DEVELOPMENT OF A TL-1 TIMBER, CURB- TYPE, BRIDGE RAILING FOR USE ON TRANSVERSE, NAIL-LAMINATED, TIMBER BRIDGES

MwRSF Research Report No. TRP-03-211-09-R1

December 2023 ADDENDUM / ERRATA

to MwRSF Report No. TRP-03-211-09

Figure 44. Connection Hardware, Test No. WVBR-1

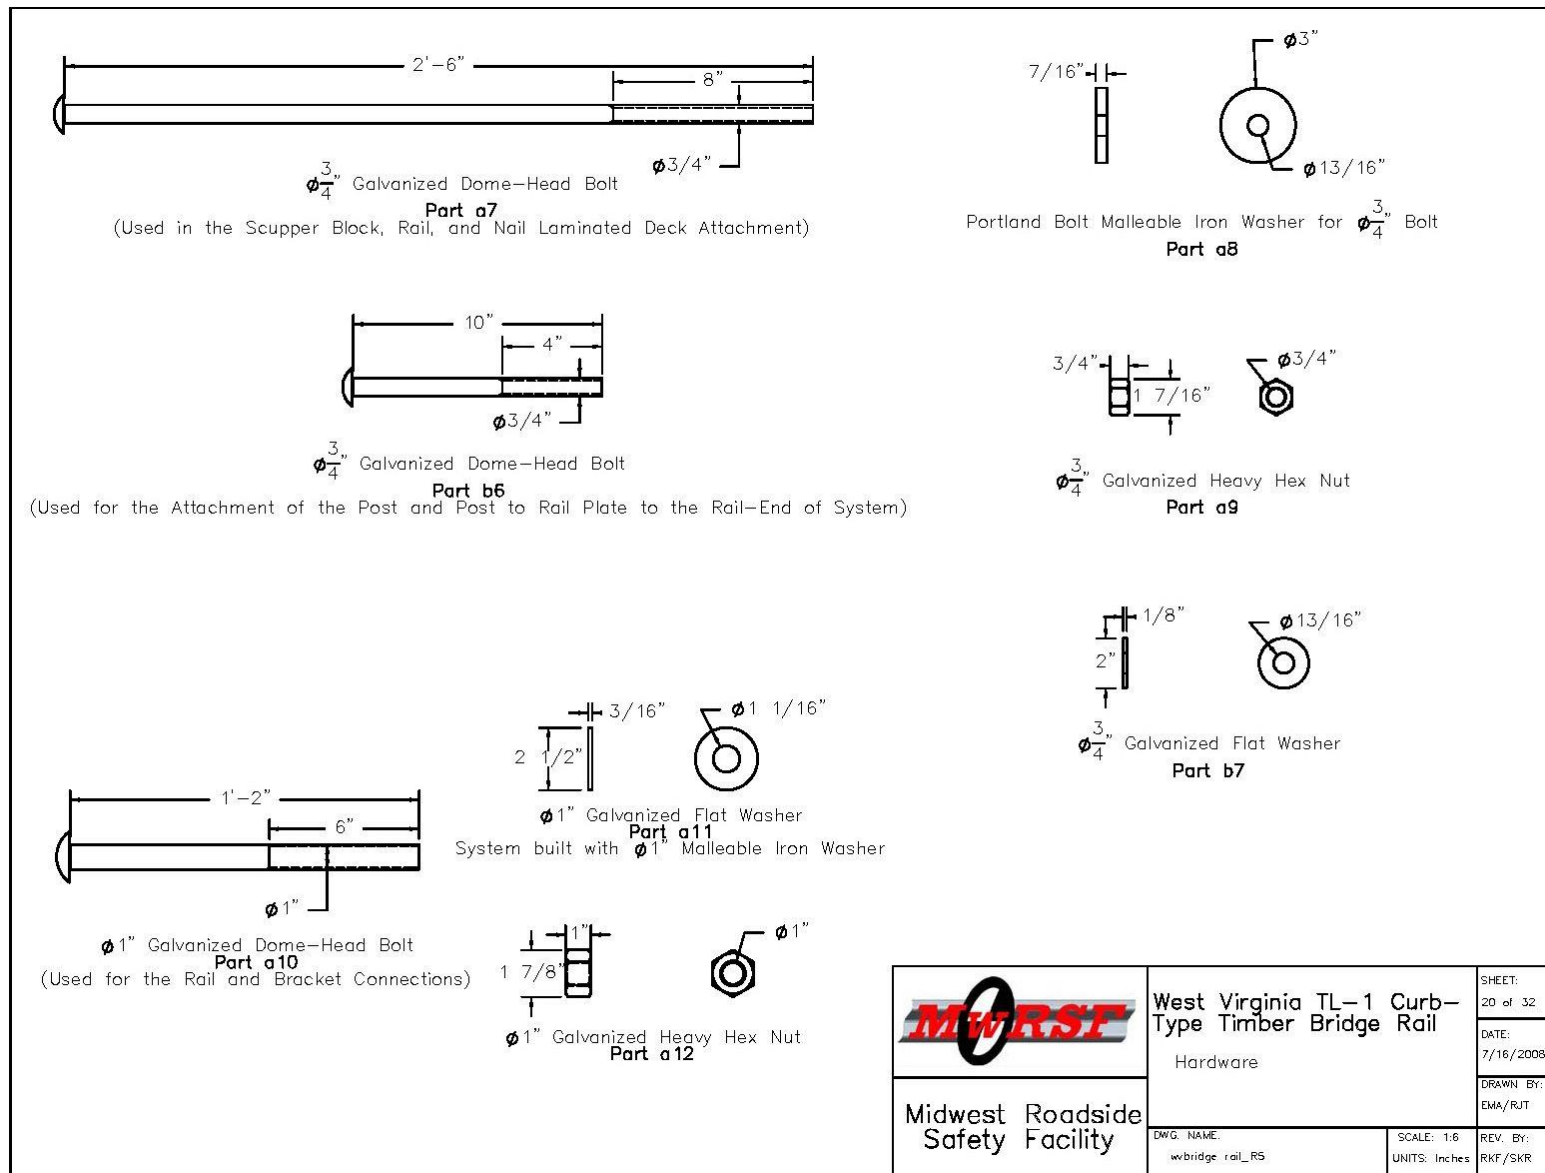
Part number for washers corrected from “a8” to “b7” on system drawing.
